Oakland Road Industrial Project

File No. H20-018

Initial Study / Mitigated Negative Declaration

RESPONSES TO PUBLIC COMMENTS AND TEXT CHANGES

Figure 3
VMT Heat Map for Workers in San Jose

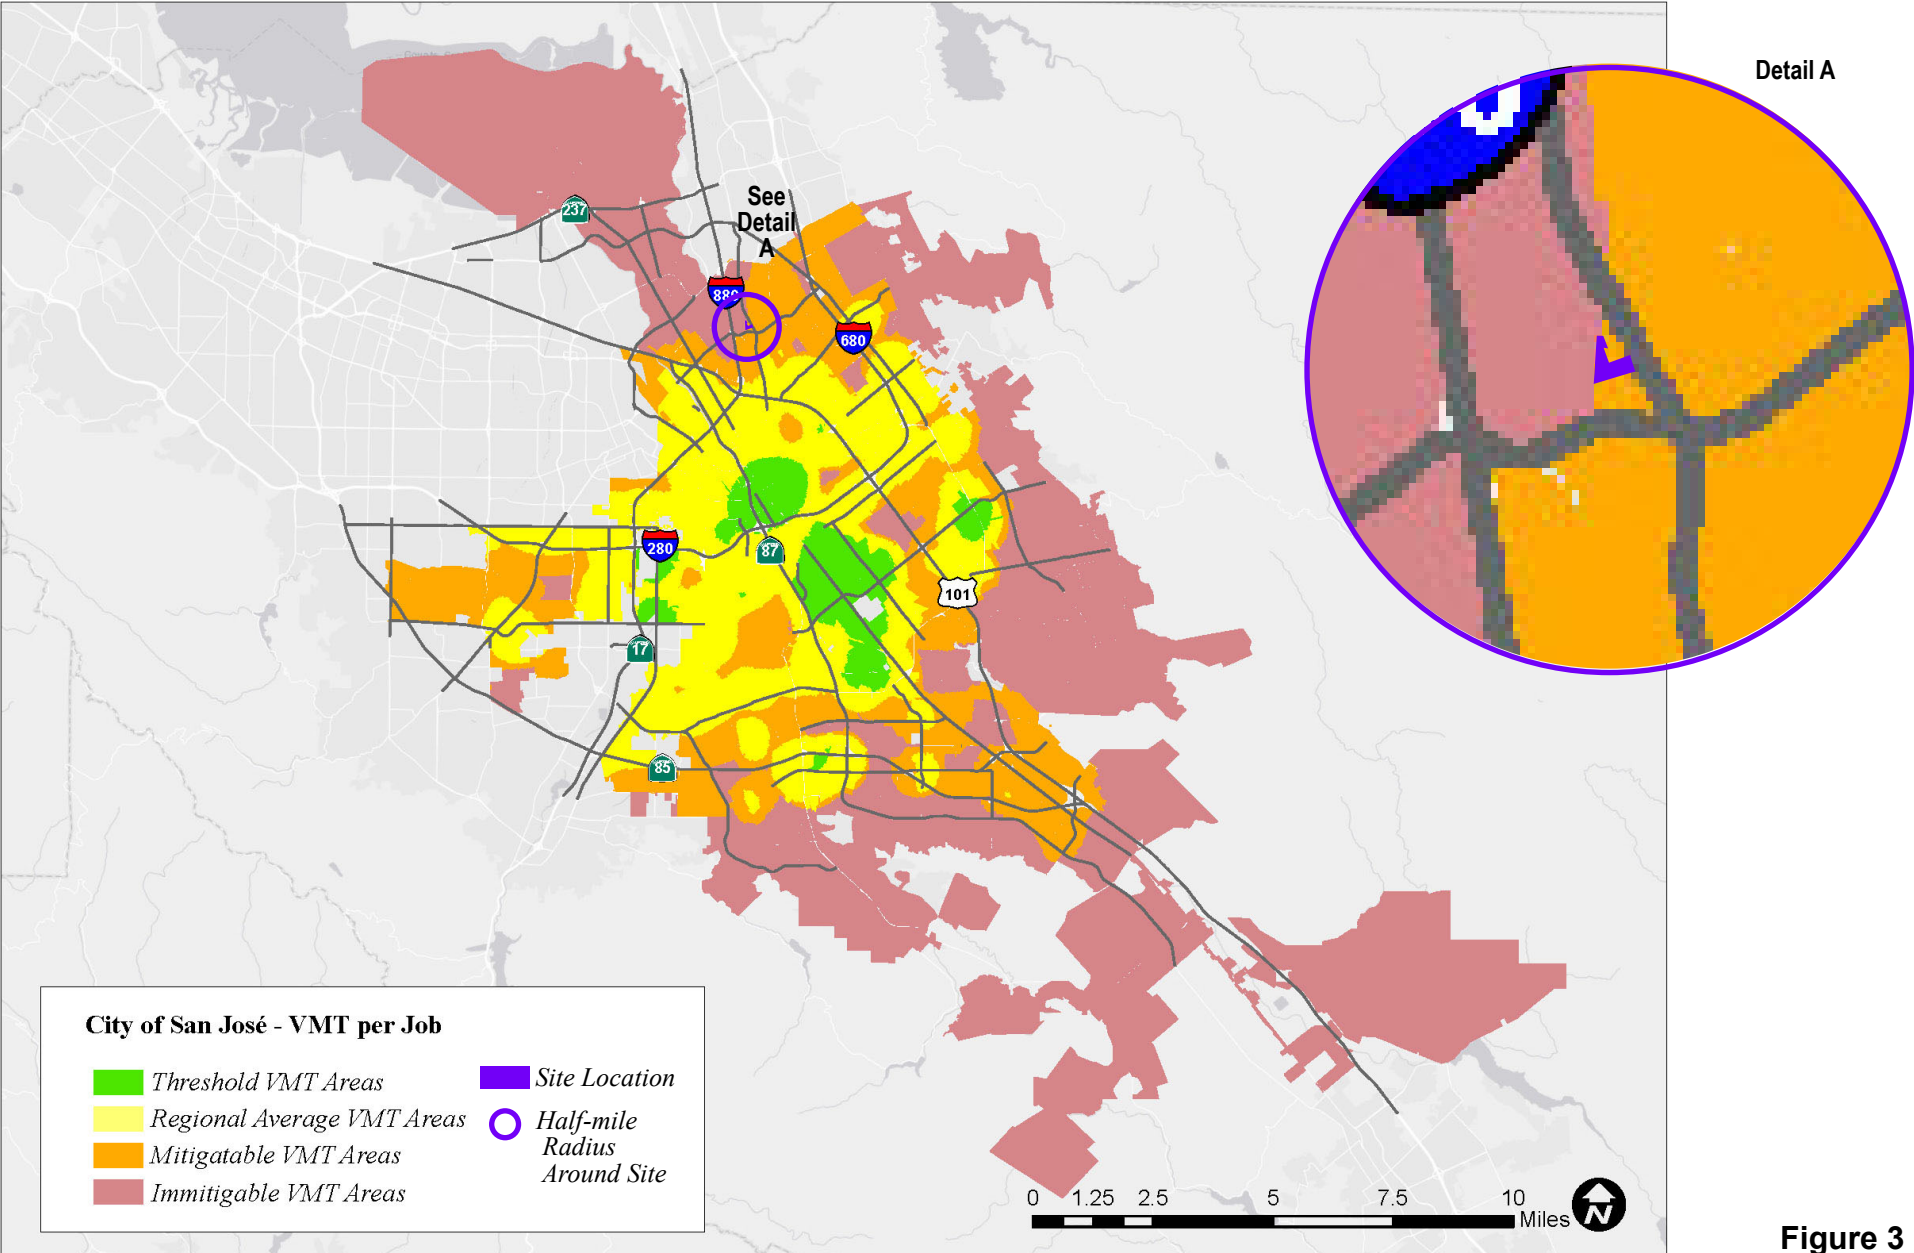
Comment B6: Figure 3 clearly shows the project site to be in an area declared “Immitigable VMT Area” by the City of San Jose. Yet in the further analysis the project is shown to be able to sufficiently mitigate VMT. Either the VMT heat map provided by the City is wrong or the VMT mitigation analysis is wrong. Which one is it? The analysis fails to address and solve this contradiction.

Figure 3¹² clearly shows the project site to be in an area declared “Immitigable VMT Area” by the City of San Jose. Yet in the further analysis the project is shown to be able to sufficiently mitigate VMT. Either the VMT heat map provided by the City is wrong or the VMT mitigation analysis is wrong. Which one is it? The analysis fails to address and solve this contradiction.

Response B6: Figure 3 in the Transportation Analysis has been revised to show the correct project location. The project site is in a “Mitigable VMT Area”. The comment does not provide new information that would require additional analysis or result in new significant impacts or mitigation measures than those analyzed and disclosed in the IS/MND and associated appendices, or present new information that would require recirculation of the IS/MND pursuant of CEQA Guideline Section 15073.5.

Intersection #3084: BROKAW/OAKLAND

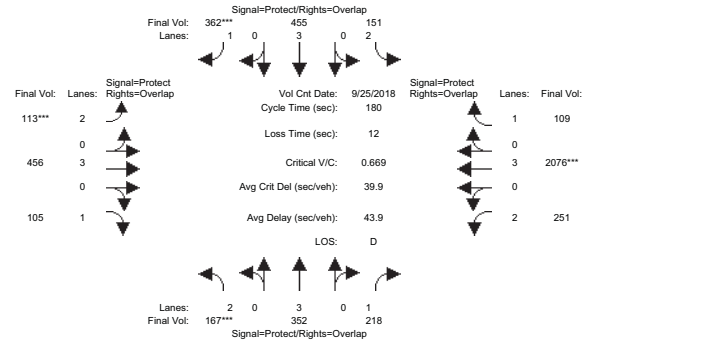
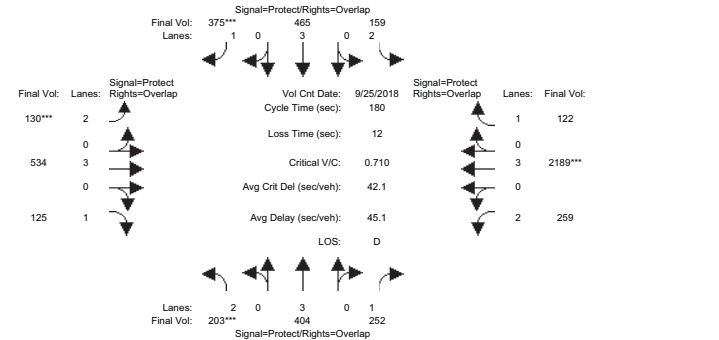
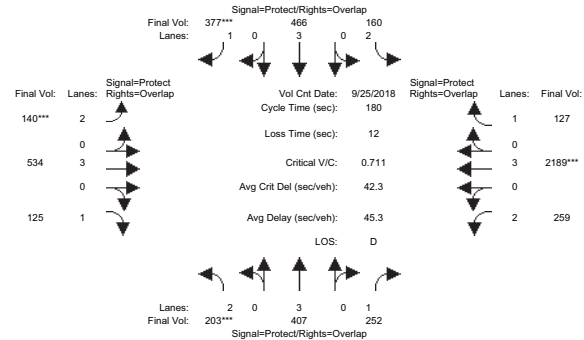
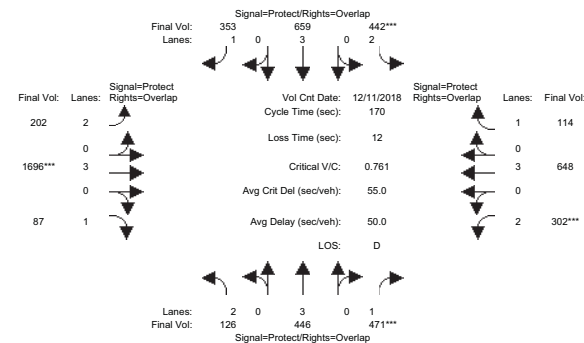
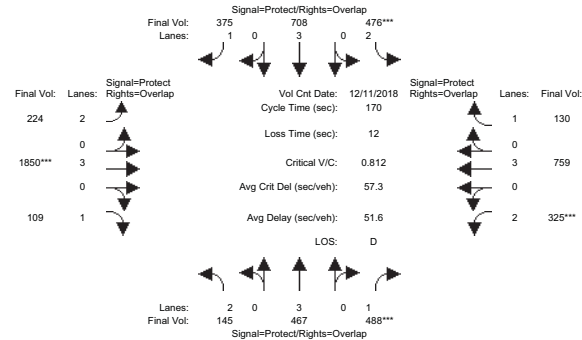
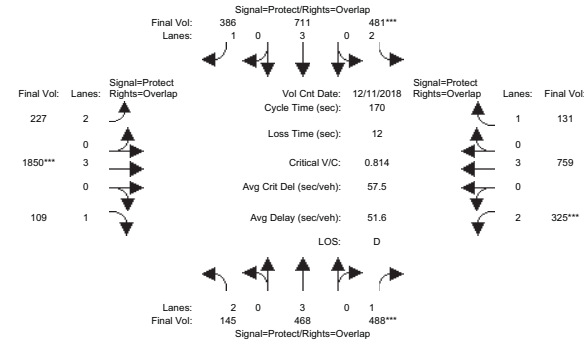
Comment B9: The intersection analysis is incurably flawed as it use unsubstantiated vehicle flow conditions in its modelling, specifically for the eastbound left turn lane from Oakland into Brokaw/Murphy. The model assumes a maximum capacity of 3150 cars/h for the two left lanes combined. Adjusted for a green time of 31.4 seconds per cycle this suggests that the model believes that ~26.25 cars are able to make a left turn per cycle. This is empirically wrong. Based on actual observations on January 29, 2019, a maximum of 16 cars is able to make a left-turn at the intersection per cycle during congested PM peak hour conditions. That means that the model is significantly underestimating the current and future delay at the intersection.

The intersection analysis is incurably flawed as it use unsubstantiated vehicle flow conditions in its modelling, specifically for the eastbound left turn lane from Oakland into Brokaw/Murphy. The model assumes a maximum capacity of 3150 cars/h for the two left lanes combined. Adjusted for a green time of 31.4 seconds per cycle this suggests that the model believes that ~26.25 cars are able to make a left turn per cycle. This is empirically wrong. Based on actual observations on January 29, 2019, a maximum of 16 cars is able to make a left-turn at the intersection per cycle during congested PM peak hour conditions. That means that the model is significantly underestimating the current and future delay at the intersection.

Response B9: The intersection level of service analysis discussed in the IS/MND followed the City of San José procedures as outlined in the Transportation Analysis Handbook, 2020. All study intersections were evaluated based on the *2000 Highway Capacity Manual* (HCM) level of service methodology using TRAFFIX software. This method evaluates signalized intersection operations on the basis of average control delay time for all vehicles at the intersection. TRAFFIX is also the Congestion Management Plan (CMP)-designated intersection level of service methodology; thus, the City of San José employs the CMP default values for the analysis parameters. The analysis of intersection operations is outside the bounds of CEQA, with passage of SB 743 requiring evaluation of projects using VMT

and the City's adoption of City Council Policy 5-1 in 2018 establishing the metrics by which CEQA transportation impacts will be evaluated using VMT. The comment does not provide new information that would require additional analysis or result in new significant impacts or mitigation measures than those analyzed and disclosed in the IS/MND and associated appendices, or present new information that would require recirculation of the IS/MND pursuant of CEQA Guideline Section 15073.5.
